TVA-BFN-TS-414 Supplement 2

**BROWNS FERRY NUCLEAR PLANT (BFN) - REDUCTION IN REQUESTED
EFFECTIVE FULL POWER YEARS (EFPY) FOR TECHNICAL
SPECIFICATIONS (TS) CHANGE NO. 414 - PRESSURE - TEMPERATURE
(P-T) CURVE UPDATE**

PROPOSED TECHNICAL SPECIFICATION (TS) CHANGE TS-414 SUPPLEMENT
2

**Figure 3.4.9-1
Pressure/Temperature Limits**

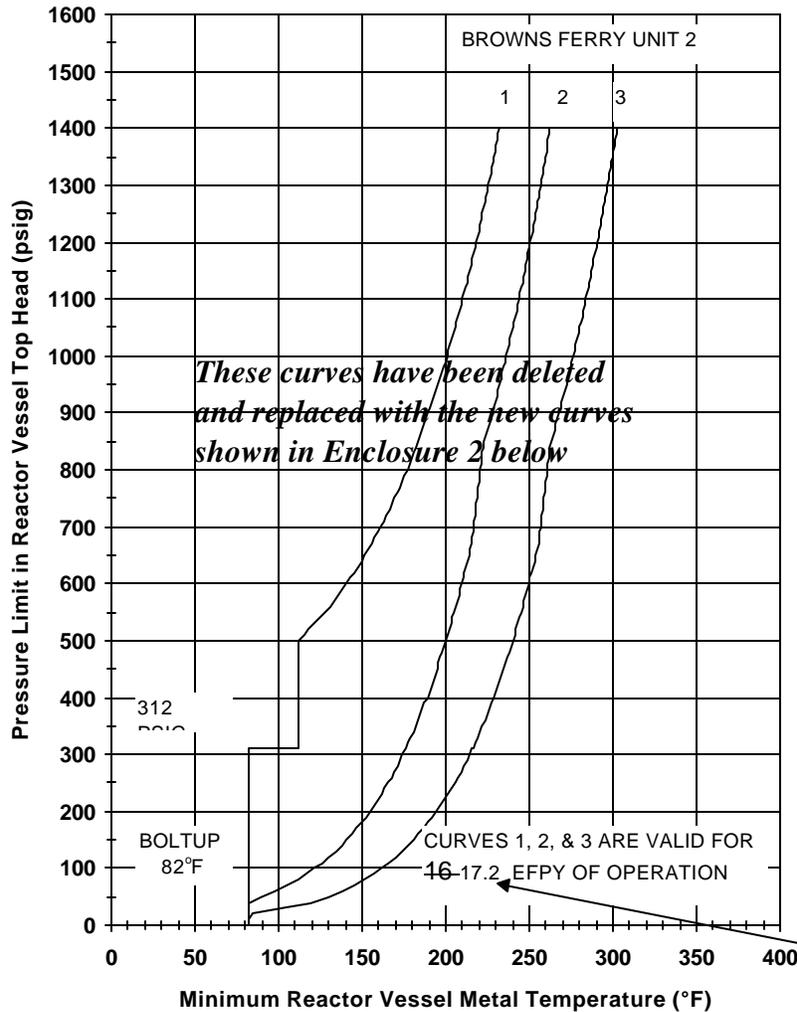
Added "ASME" for additional clarity in this note.

Notes
These curves include sufficient margin to provide protection against feedwater nozzle degradation. The curves allow for shifts in RT_{NDT} of the Reactor vessel beltline materials, in accordance with Reg. Guide 1.99, Rev. 2, to compensate for radiation embrittlement for ~~16~~ 17.2 EFPY.

The period of valid use of these curves has been changed from 16 to 17.2 EFPY.

**Figure 3.4.9-1
Pressure/Temperature Limits**

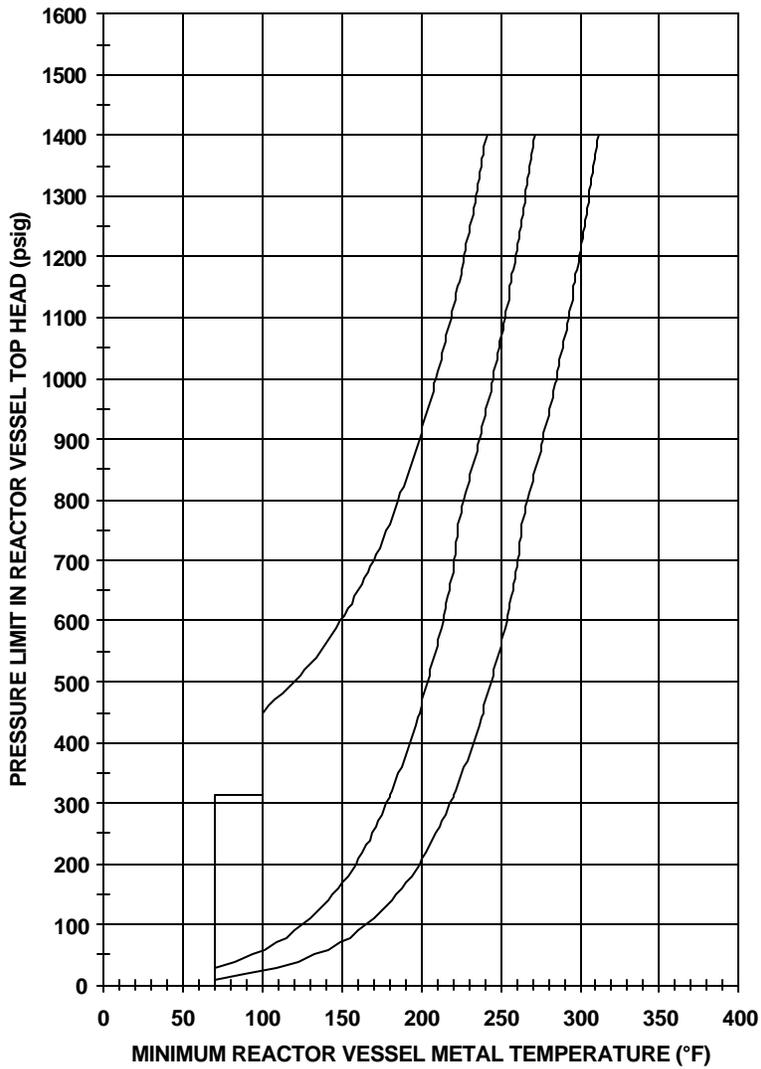
Added "ASME" for additional clarity in this note.

These curves include sufficient margin to provide protection against feedwater nozzle degradation. The curves allow for shifts in RT_{NDT} of the Reactor vessel beltline materials, in accordance with Reg. Guide 1.99, Rev. 2, to compensate for radiation embrittlement for 20 13.1 EFPY.

These curves have been deleted and replaced with the new curves shown in Enclosure 2 below

CURVES 1, 2 & 3 ARE VALID FOR 20 13.1 EFPY OF OPERATION

The period of valid use of these curves has been changed from 20 to 13.1 EFPY.
